**City of Portland, Maine - Building or Use Permit Application**

Permit No: 01-0407	Issue Date: <b>APR 27 2001</b>	CBL: 159 D009001
-----------------------	-----------------------------------	---------------------

### BUILDING PERMIT REPORT

REASON FOR PERMIT: To Construct an 8x12 shed

31 Murray Street - Portland Maine

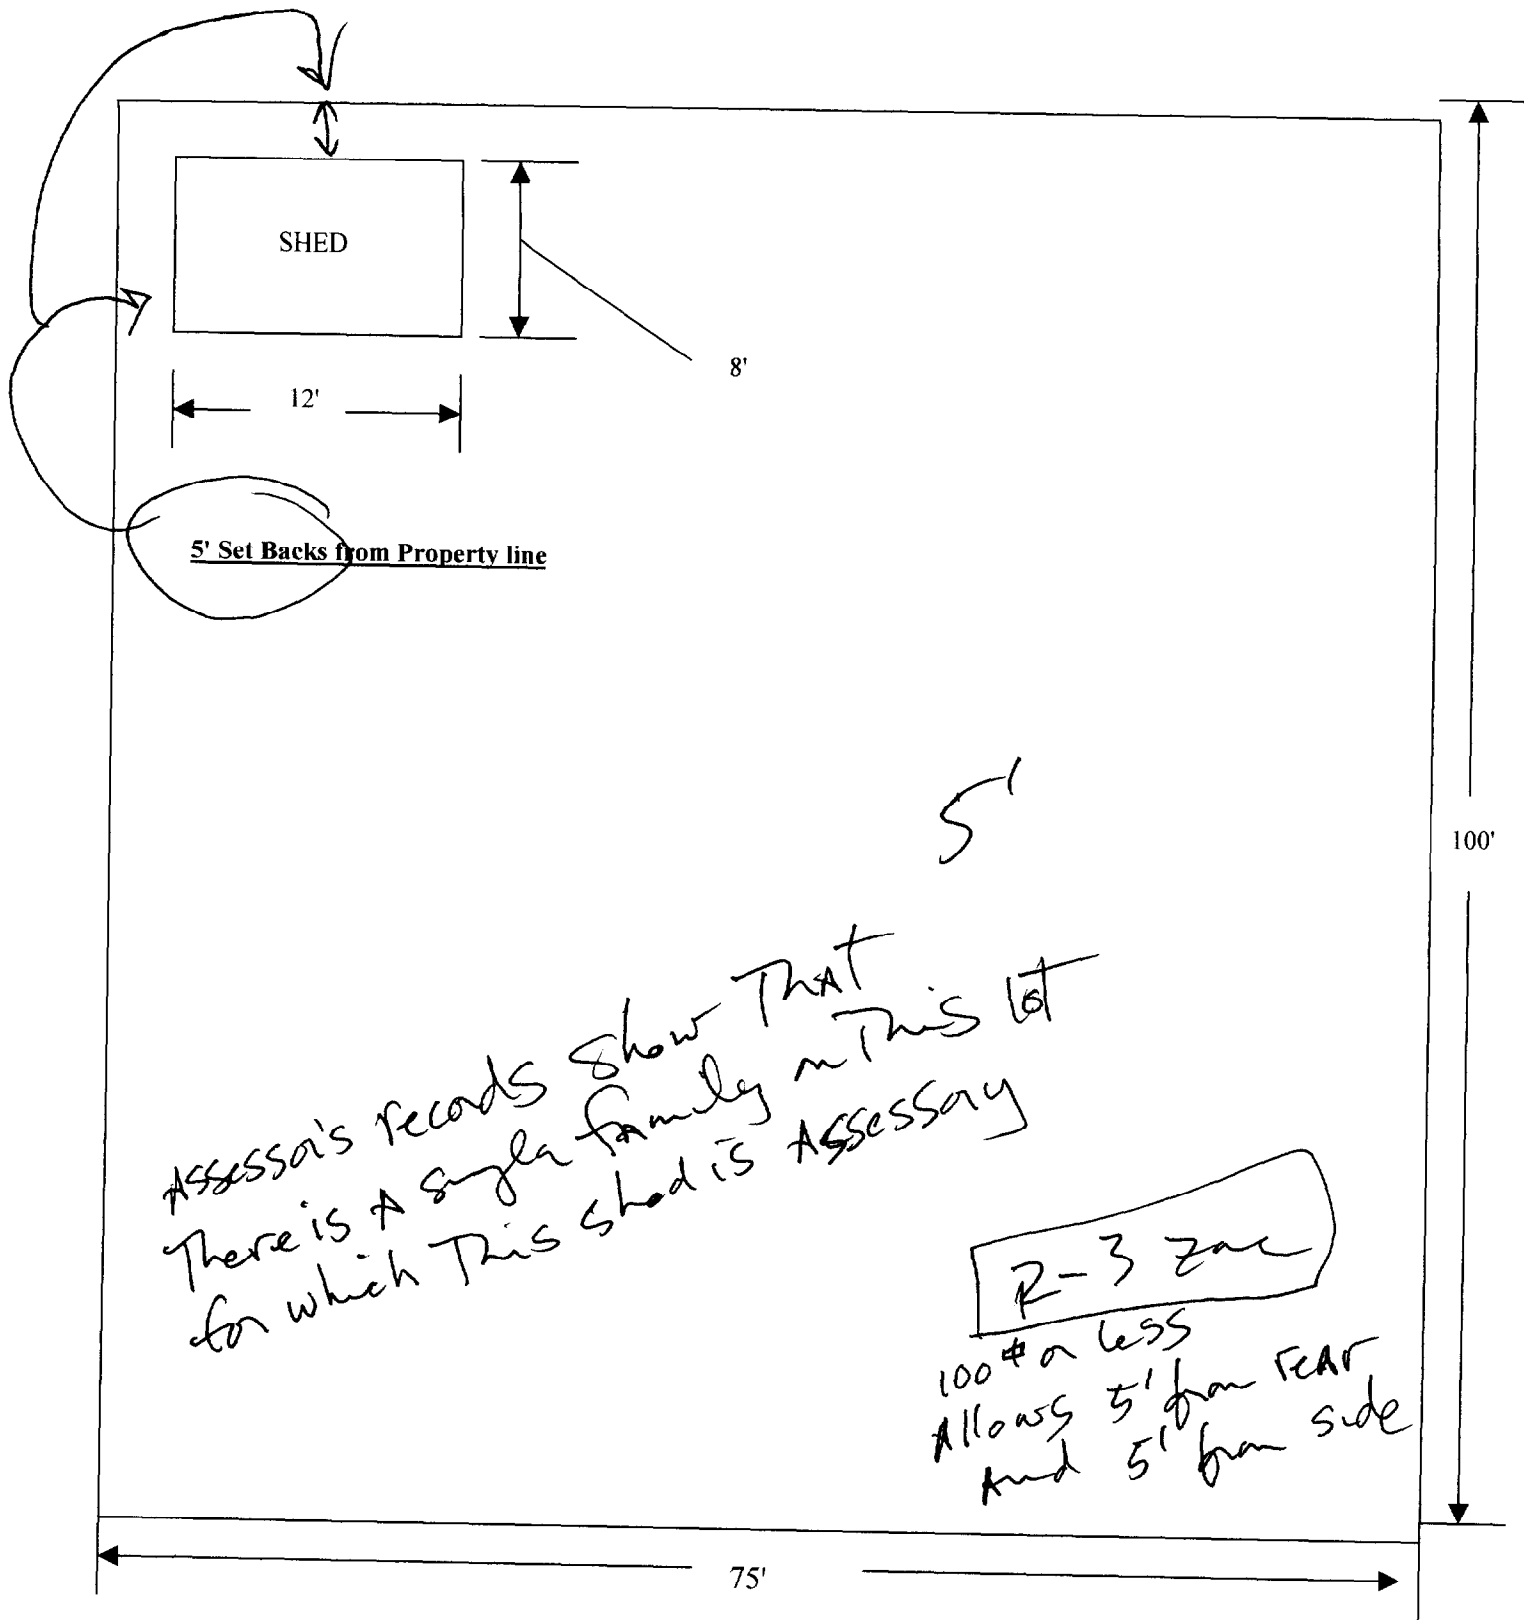
- 32. Please read and implement the attached Land Use Zoning report requirements. *Shed not allowed in front yard or 25' setback is require*
- 33. Boring, cutting and notching shall be done in accordance with Sections 2305.3, 2305.3.1, 2305.4.4 and 2305.5.1 of the City's Building Code.

- 38. *Call before placing shed, to have setbacks checked,*
